Architectural & Community Appearance Board of Review

Project Name: 854 Bradley Parkway. ACABOR decision #22-29

Project Address 854 Bradley Parkway, Blauvelt, New York 10913

Variance to decision #22-29

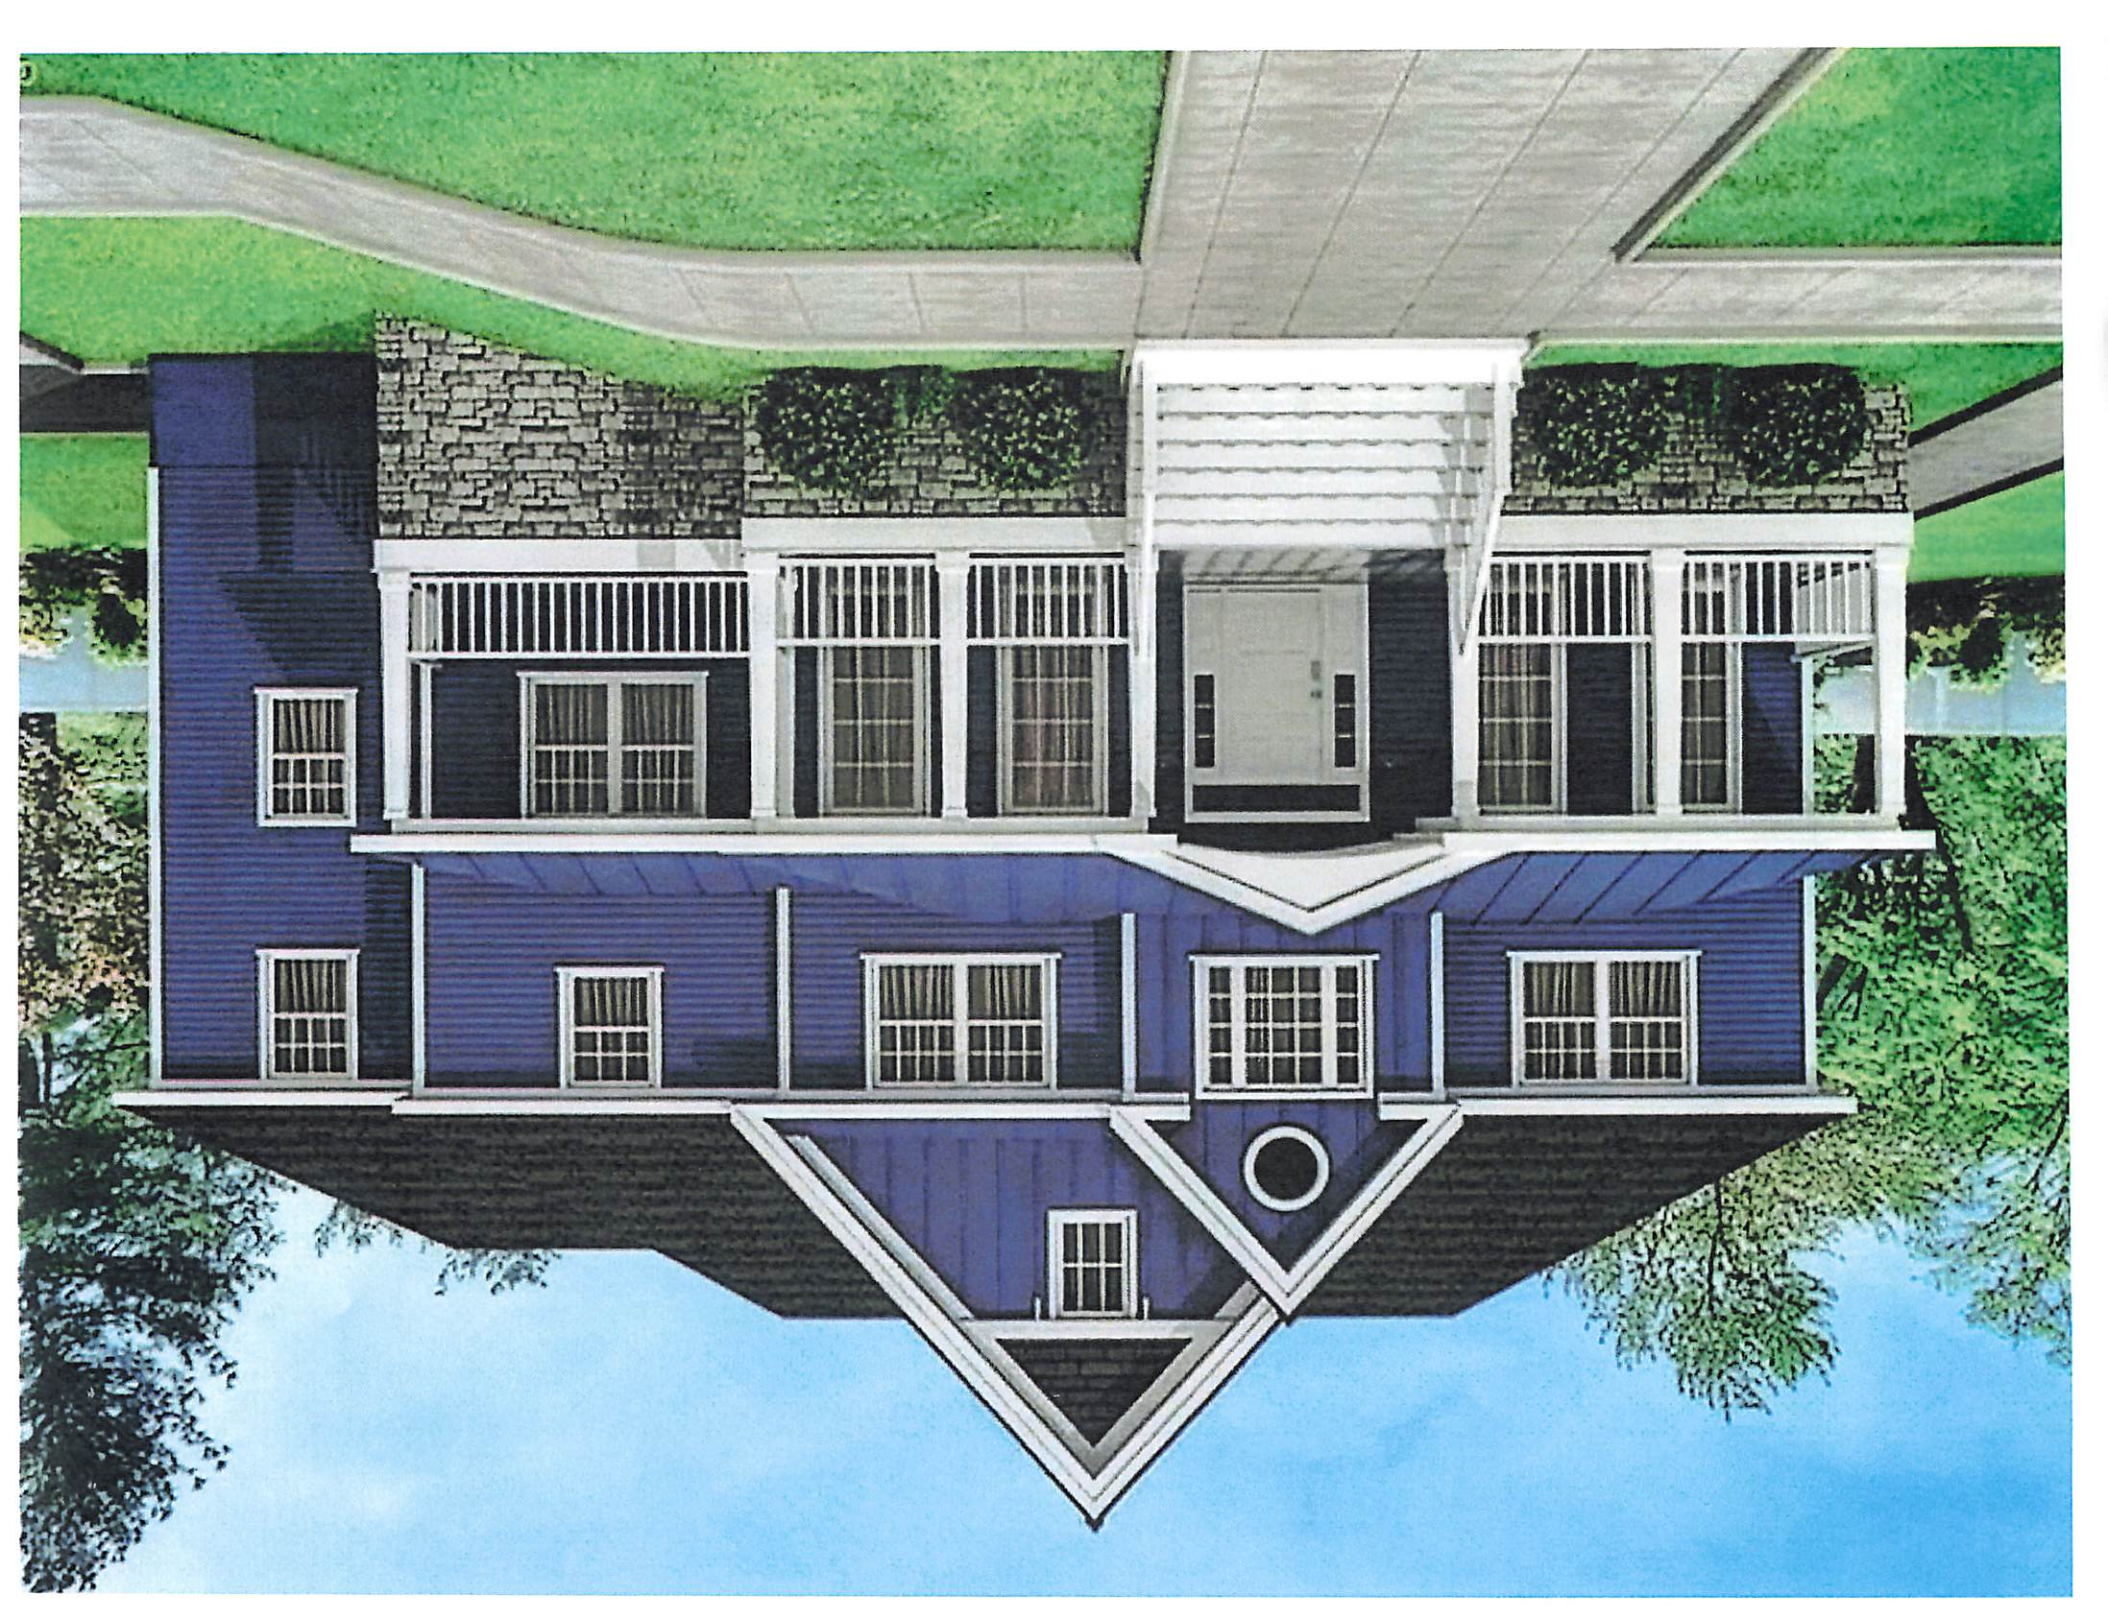
1. Changed the lower front porch deck from Stone veneer to TREX lattice to match the TREX deck in chocolate brown and added juniper gold trees to landscape to blend in with the existing landscape. This change better aligned with the modern farmhouse aesthetics of the property while also keeping the stone veneer feature on the foundation and on the sides. Budget was also a consideration.
2. Changed siding from Vinyl to James Hardie Plank. Removed vinyl shake siding decorative feature. No change in color scheme.
3. Painted front door black (previously white). White trim remains
